SERVICE BULLETIN

TITLE: LANDING GEAR - INSTALLATION OF UPLOCK STOP BRACKET BOLTS

This Service Bulletin is being issued to clarify proper uplock stop bracket bolt type and installation when a new design lower lift leg (with a larger uplock stop contact area) is installed on any of the affected aircraft which have either been manufactured with, or modified to include, uplock stop brackets. If the main landing gear lower lift leg comes in contact with the uplock stop bracket bolts while cycling the landing gear, the retract rod can be damaged preventing full extension of the landing gear. It is also possible that the lower lift leg may hang on the uplock stop bracket bolts, if they are incorrectly installed, which could prevent the main gear from extending.

Main Landing Gear Uplock Stop Bracket Installation
Figure 1

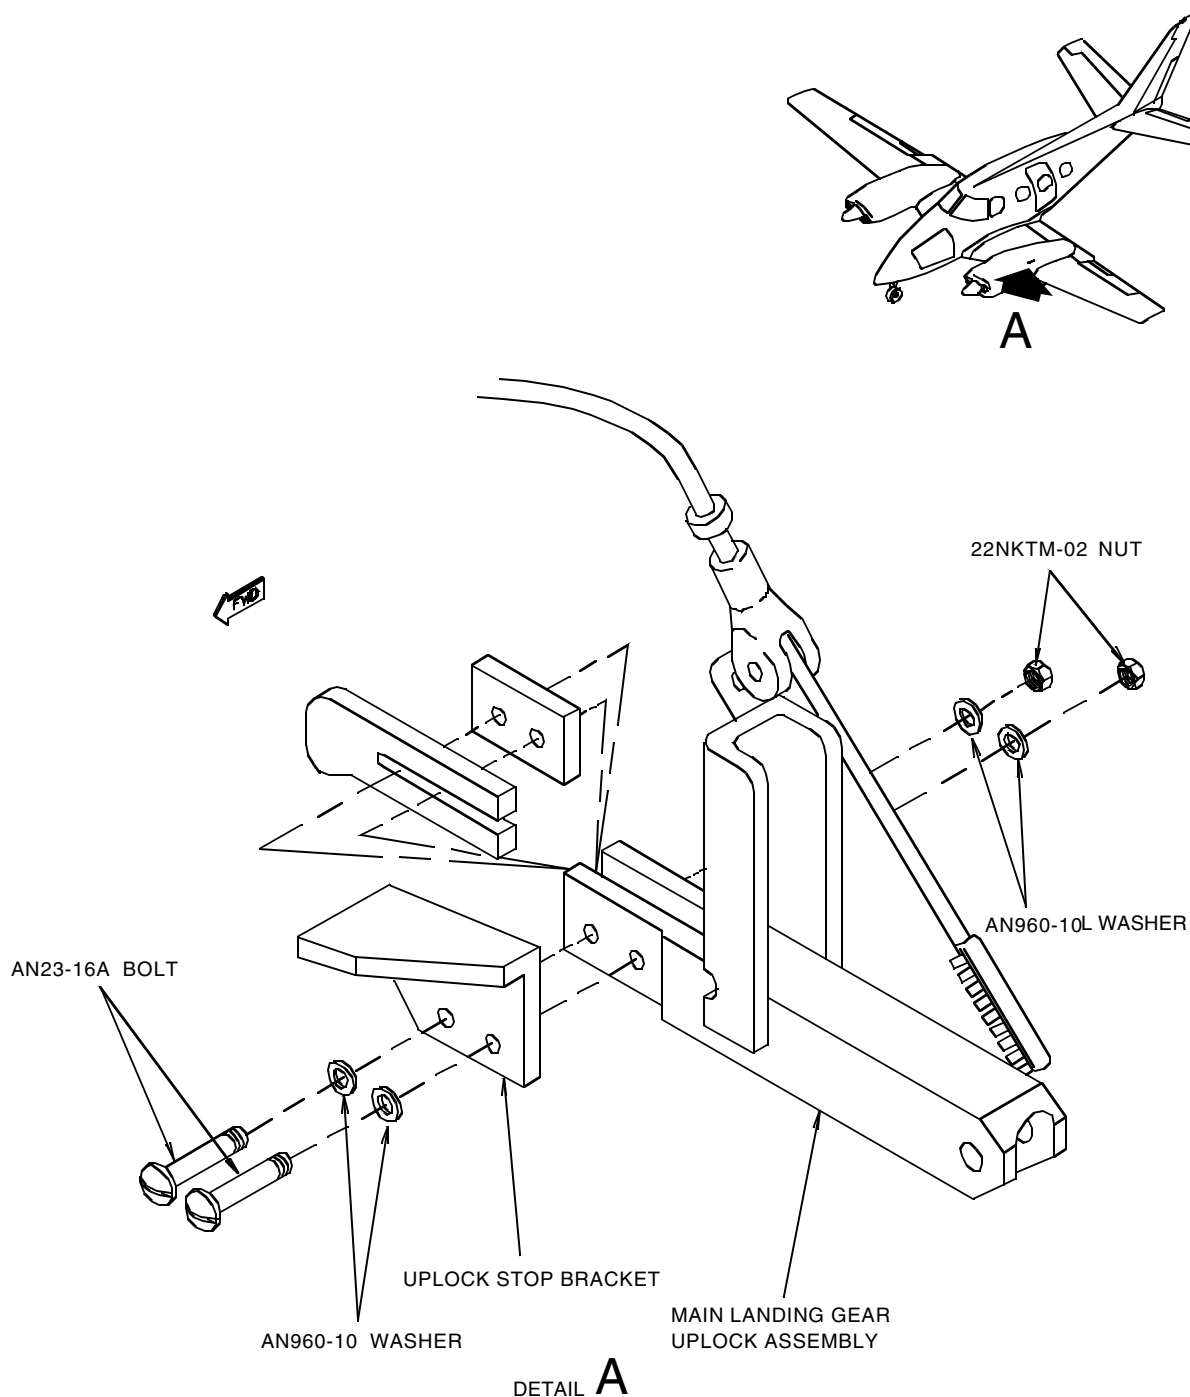
- (1) Remove all power from the airplane and disconnect the battery.
- (2) Refer to Chapter 7 of the appropriate Maintenance Manual and place the airplane on jacks.
- (3) Refer to Figure 1 and accomplish the following:
 - (a) Observe the bolts that secure the uplock stop bracket to the uplock assembly. They should be type AN23-16A (pan heads with screwdriver slots as opposed to hex heads) and should be installed with the threaded ends facing aft (the nuts should be on the aft side of the uplock assembly).

- (b) If the uplock stop bracket bolts ARE NOT the correct type, they must be replaced.
 - (c) If the uplock stop bracket bolts ARE the correct type but installed facing the wrong direction, they and the accompanying hardware must be removed, thoroughly inspected for damage, and re-installed as necessary.
 - (d) Repair damaged finish if required as directed in Chapter 20-00 of the applicable Maintenance Manual using materials listed in Parts Schedule II.
- (4) Reconnect the airplane battery, remove warning notices and restore power.
